PROPOSED IMPROVEMENT
BRIDGE PROJECT
WINDSOR-HARTFORD
COUNTY OF WINDSOR
ELEVEN BRIDGES ON I-91

Record Plans

PROJECT DESCRIPTION: THIS PROJECT INVOLVES CLEANING, LEAD PAINT REMOVAL AND REPAINTING THE EXISTING STEEL SUPERSTRUCTURE MEMBERS AND ASSOCIATED WORK.

DIRECTOR OF PROJECT DELIVERY
APPROVED: Mark Sargent DATE 7/2/2015
PROJECT MANAGER : MARK SARGENT
PROJECT NAME : WINDSOR-HARTFORD
PROJECT NUMBER : IM BPNT (13)
SHEET 1 OF 36 SHEETS

4IS SOUTH BOUND BRIDGE
PLAN VIEW DOWN SPOUTS

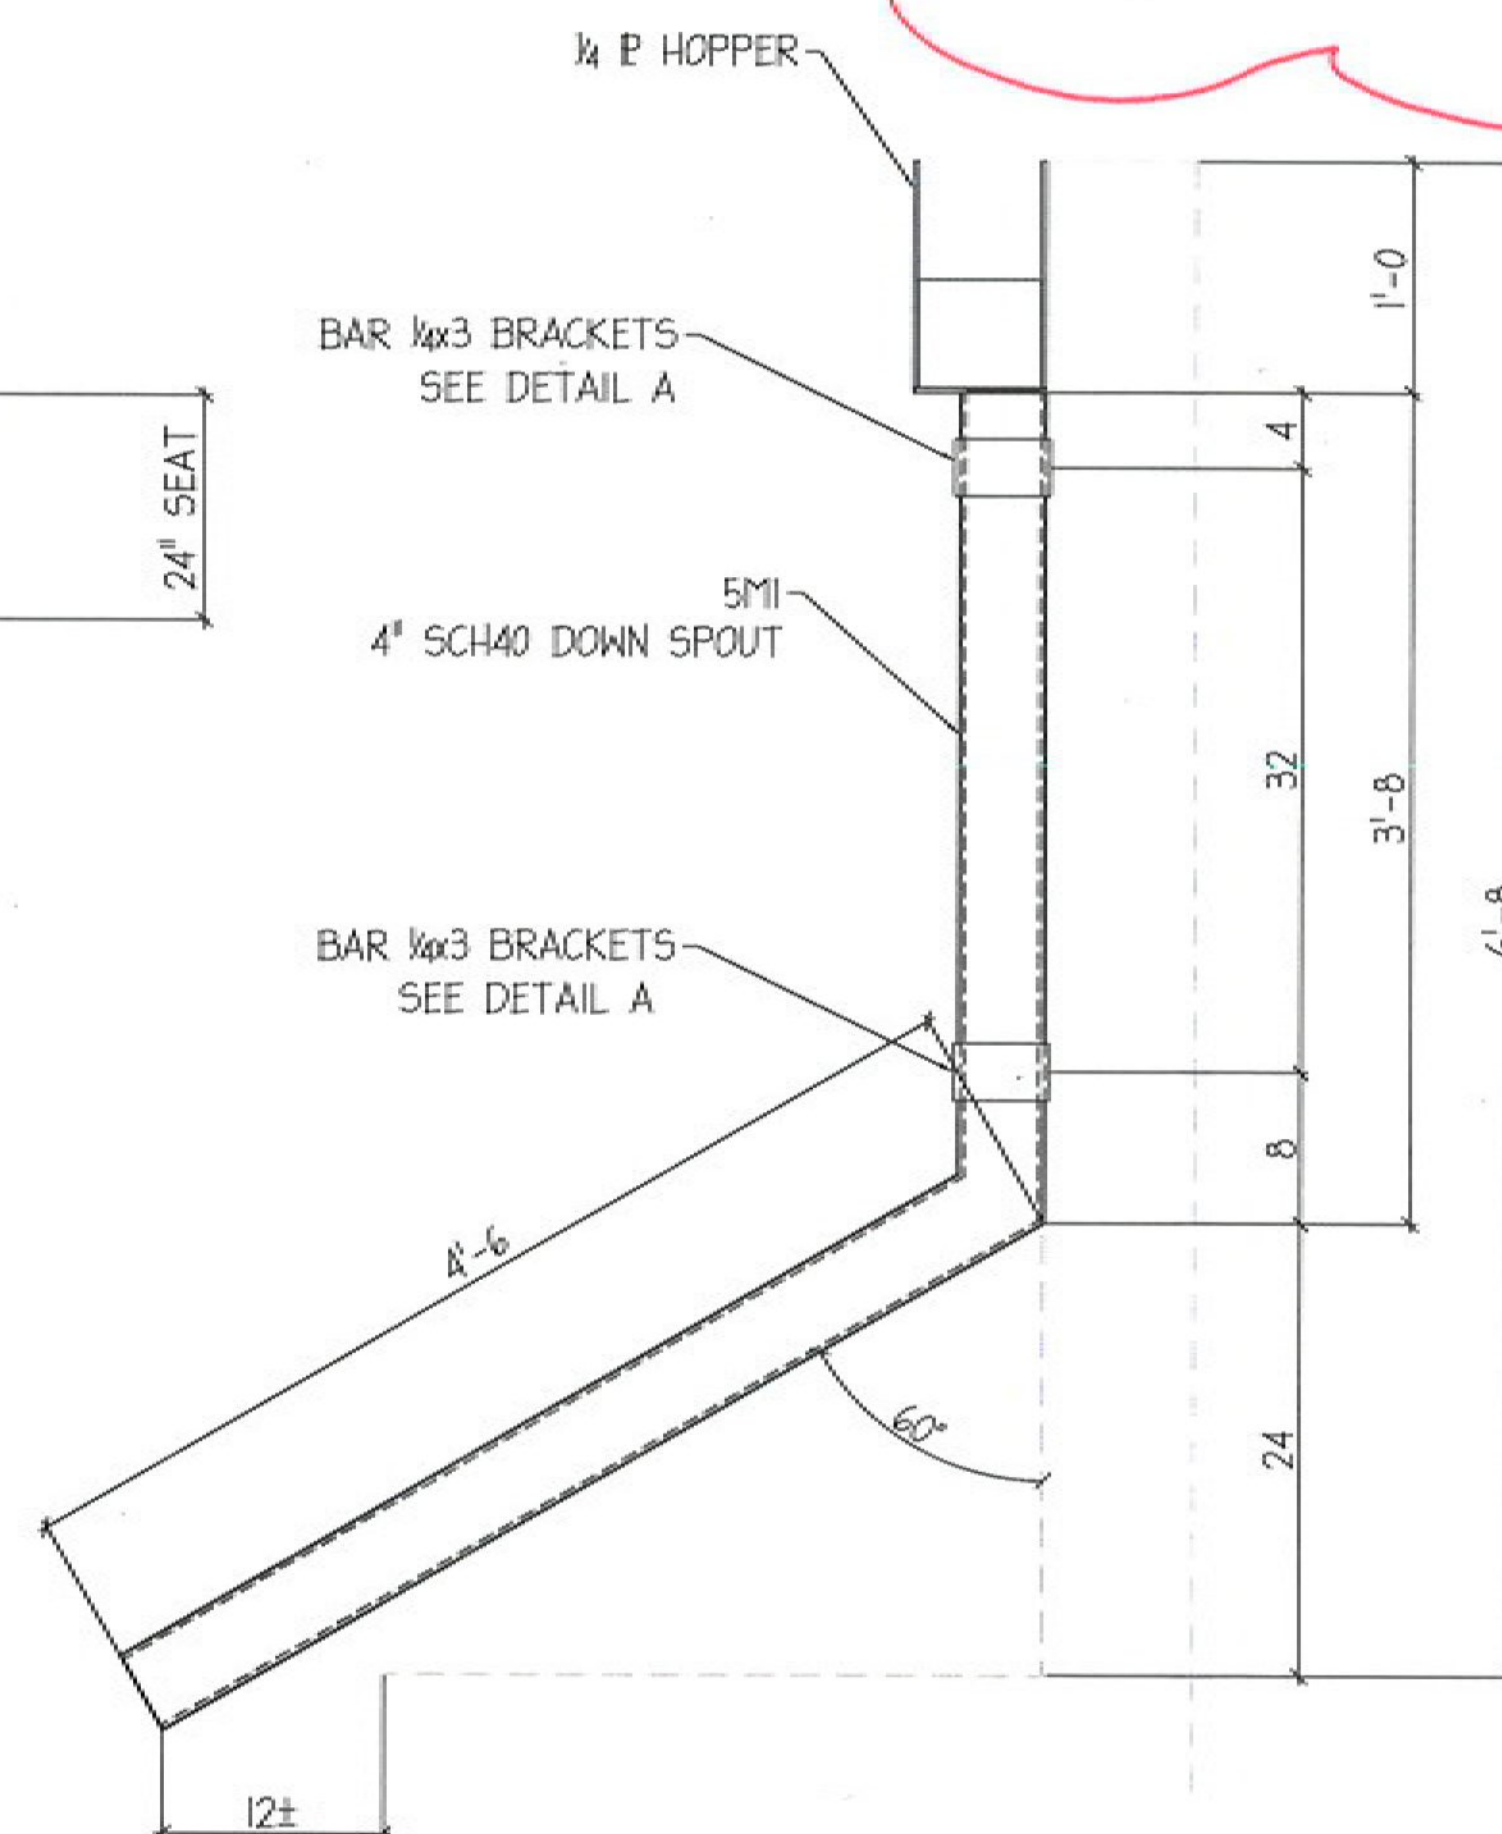
PER FIELD VERIFICATION BY MONOKO, LLC
THERE ARE NO EXISTING DOWNSPOUTS ON
SOUTH BOUND BRIDGE 4IS, IF DOWNSPOUTS
ARE NEEDED PLEASE CONFIRM

PLAN VIEW V TROUGH'S

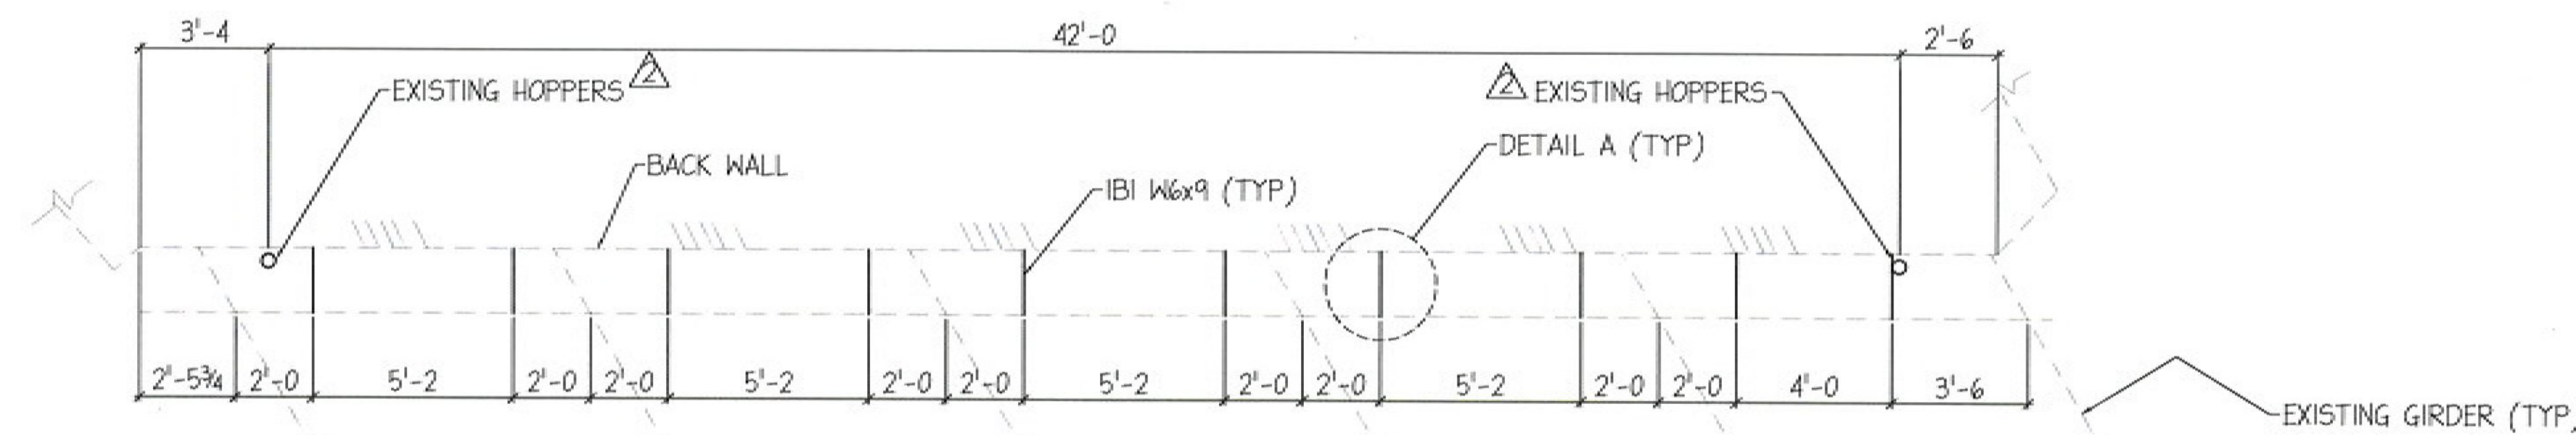
NOTE:
DETAIL ENLARGED PER REV. 2
TO CLARIFY DIMENSIONS/DETAIL
QUESTIONS
